MODIFICATION #1
WEST LILAC ROAD - BRIDGE TO HIGHWAY 395

Request for a
Modification to a Road Standard
and/or to Project Conditions

Project Number: TM 5571/5572 Date of Request: April 3, 2013

ATTACHMENT 1
LILAC HILLS RANCH: 2.2C LIGHT COLLECTOR
MODIFICATION TO ROAD STANDARDS

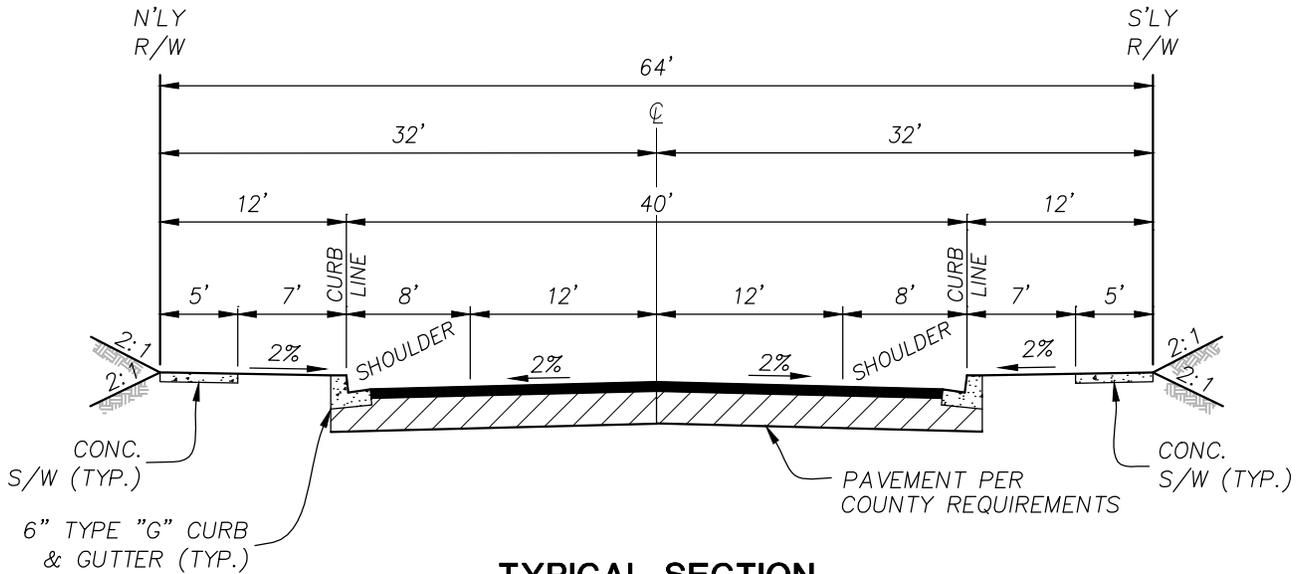
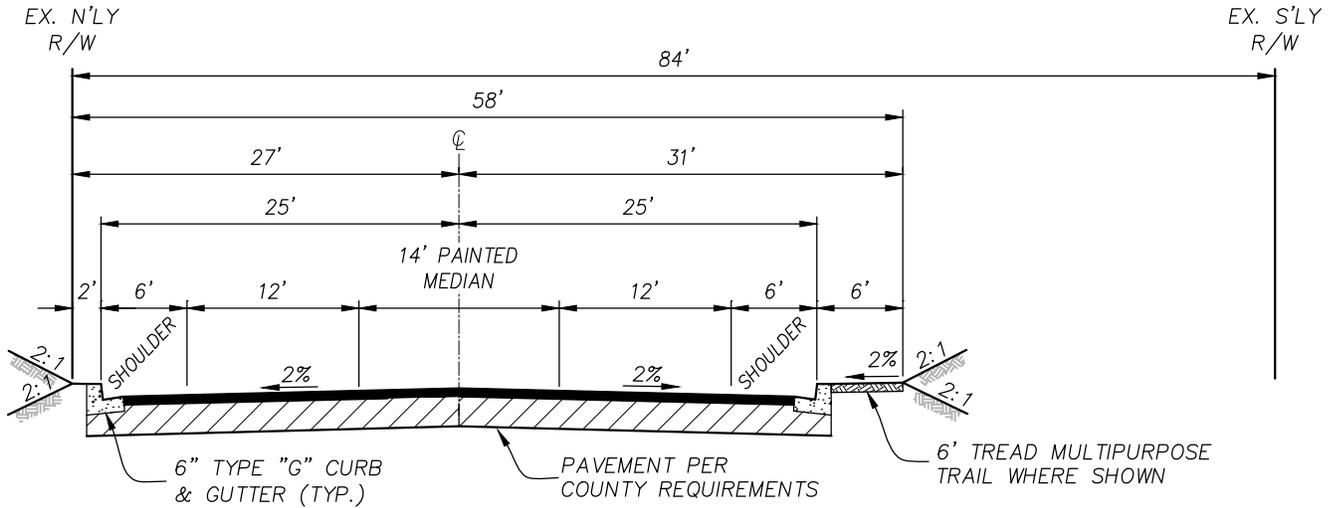
The standard road section for Light Collector Road 2.2C is 40'-54' wide curb to curb
width on 64'-78' ROW. 8' shoulders, and 12' parkways with a minimum design speed of 40 mph.
The requested modification to the road standard is to reduce the shoulder from to 6ft and
reduce the parkway to 2' (north) and 6' (south). Please see Attachment 1 for more information.

ATTACHMENT 2 WITH MODIFICATION #1 INTERSTATE 15 TO OLD HIGHWAY 395

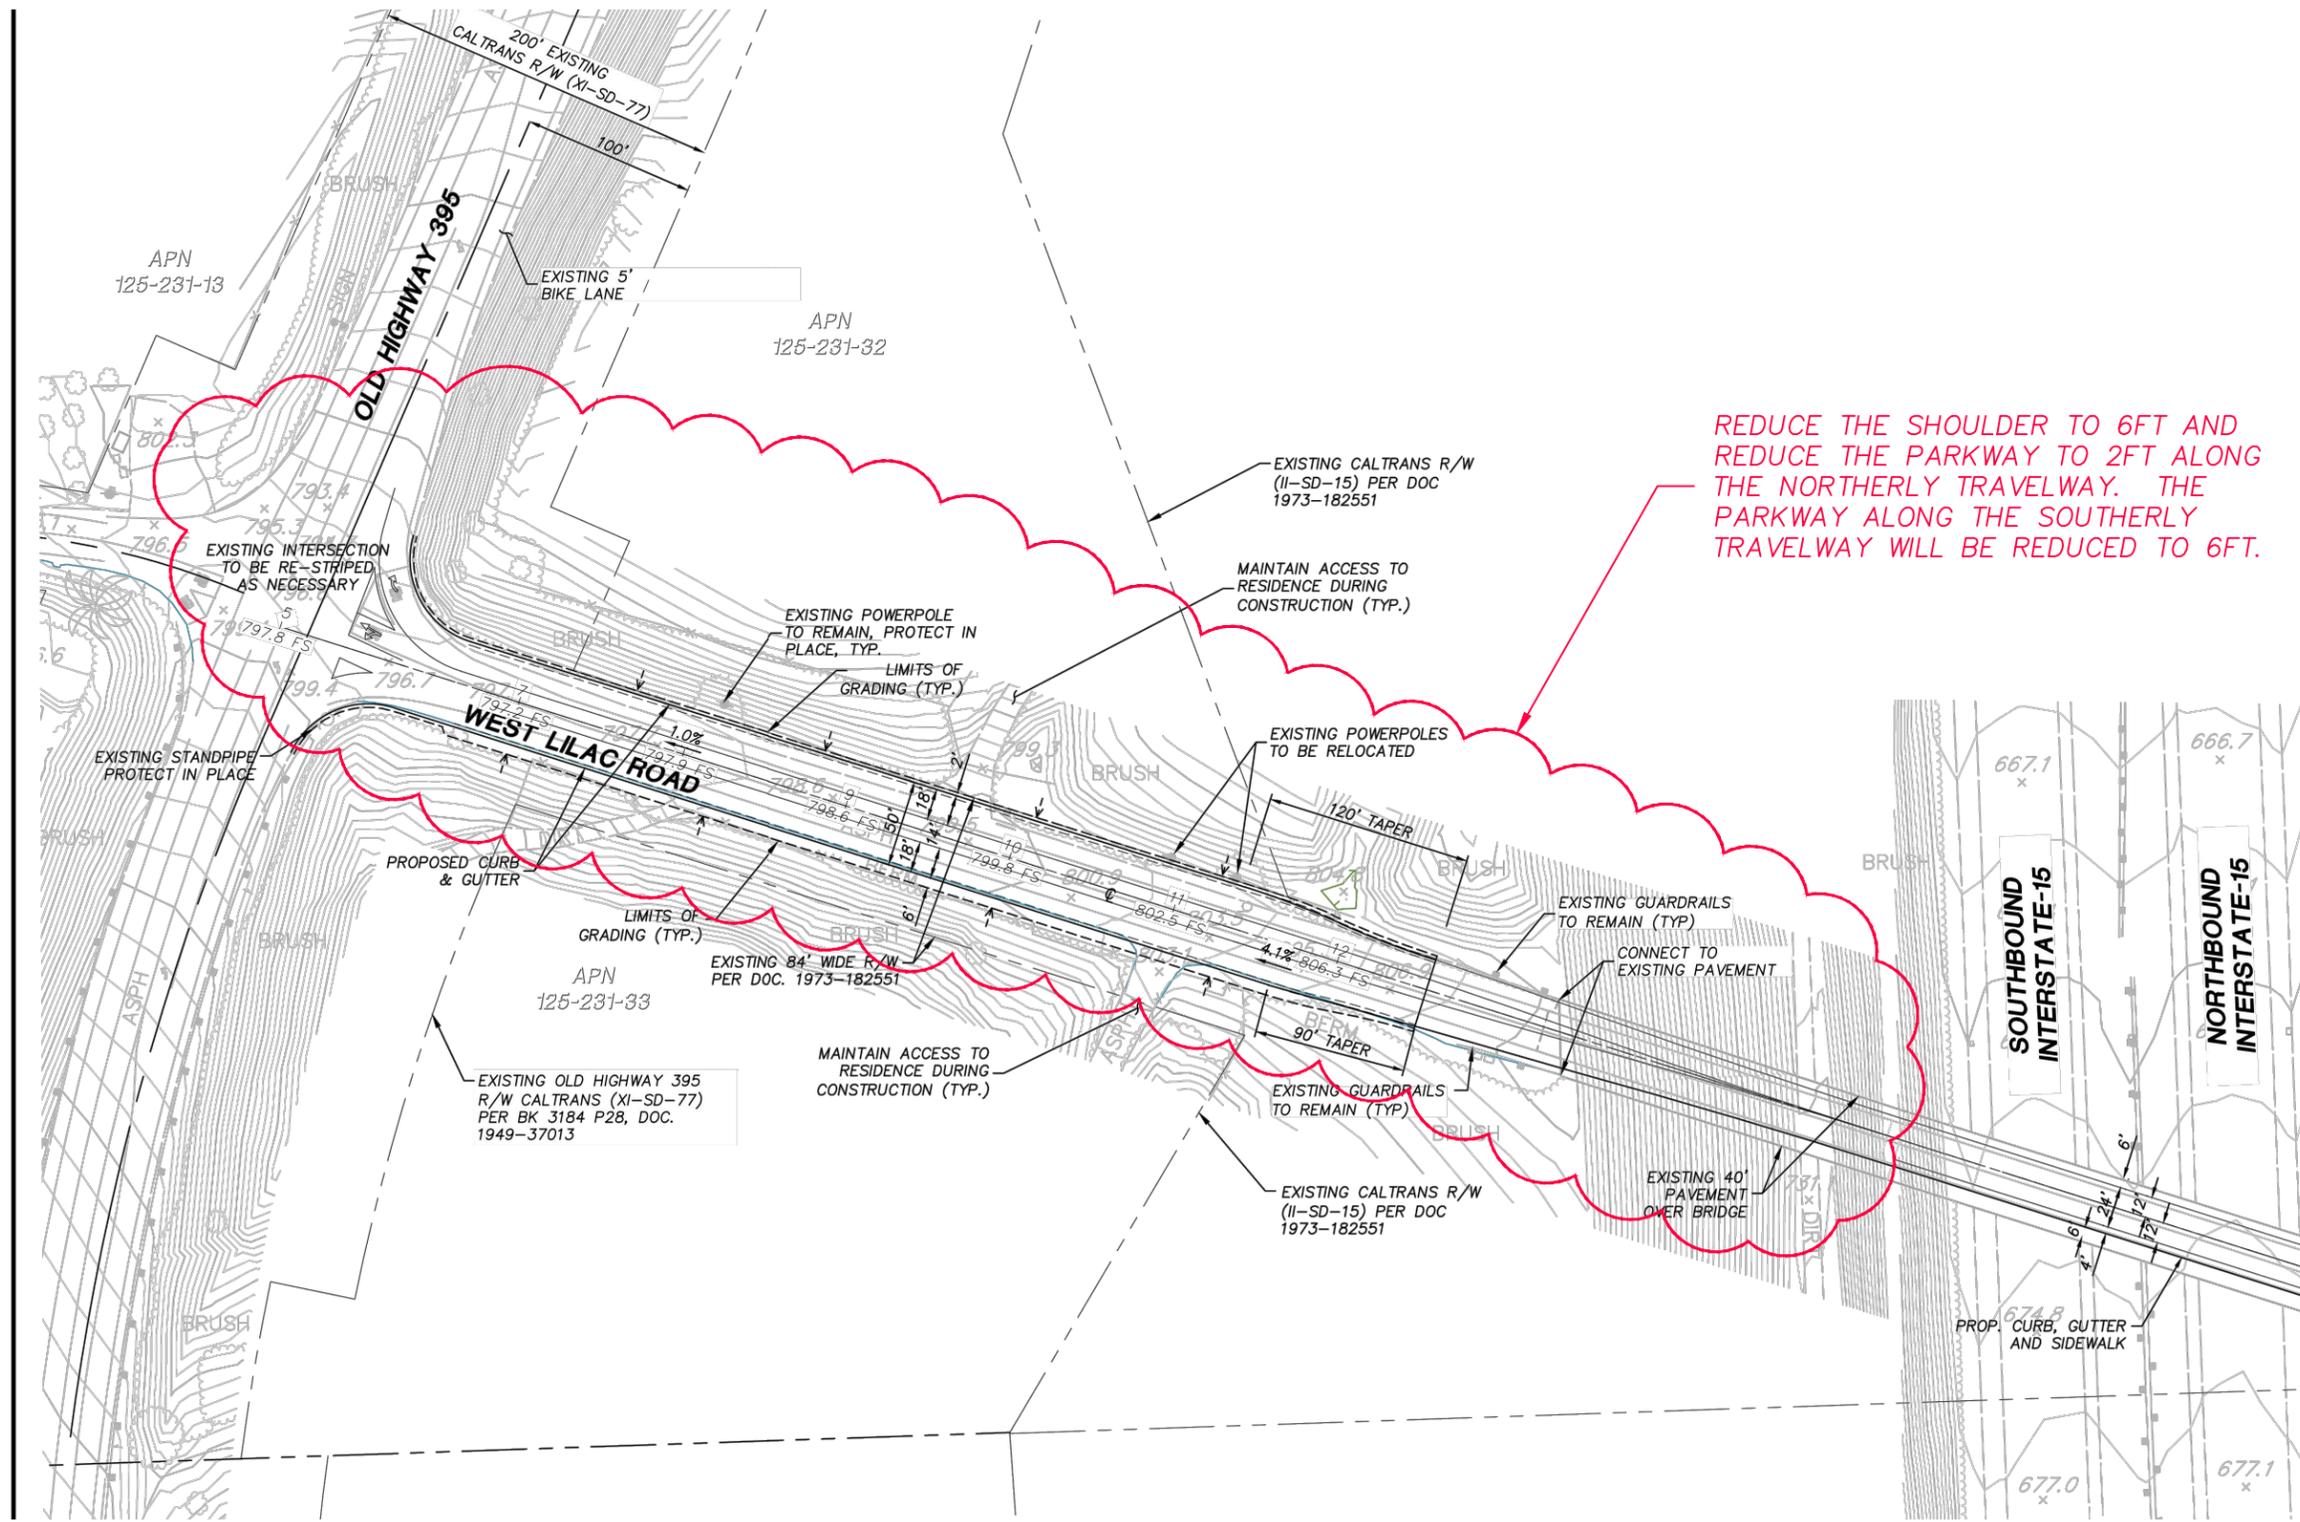
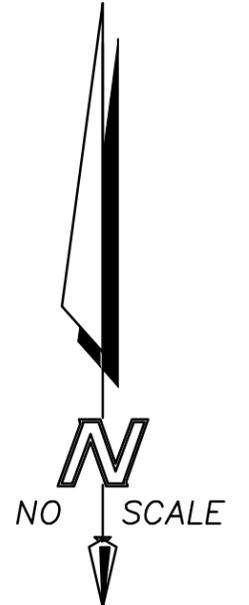
REDUCE THE SHOULDER TO 6FT AND REDUCE THE PARKWAY TO 2FT ALONG THE NORTHERLY TRAVELWAY. THE PARKWAY ALONG THE SOUTHERLY TRAVELWAY WILL BE REDUCED TO 6FT.
